St. Joseph County VA Clinic

VA ST. JOSEPH
COUNTY CBOC

06/03/16 Revised Signage & East Entrance
7/15/16 Addendum 1

C-3.0
Site Layout Plan

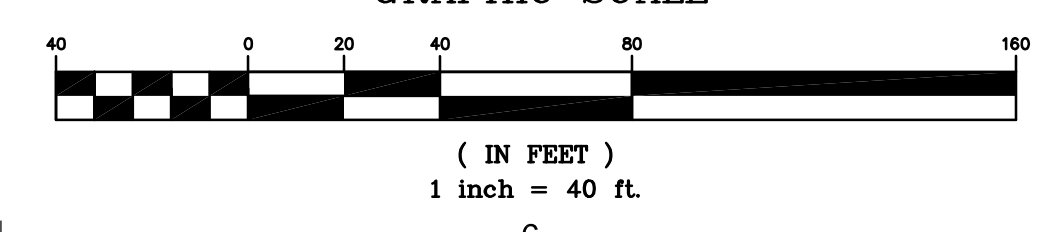
Approximate Area
for Location of
Conexes (fenced,
gated employee
parking lot, near the
Logistics
Warehouse).

Locations of the 3 red arrows on this drawing show approximate possible locations on VA Property where Conexes will be planned to be placed.
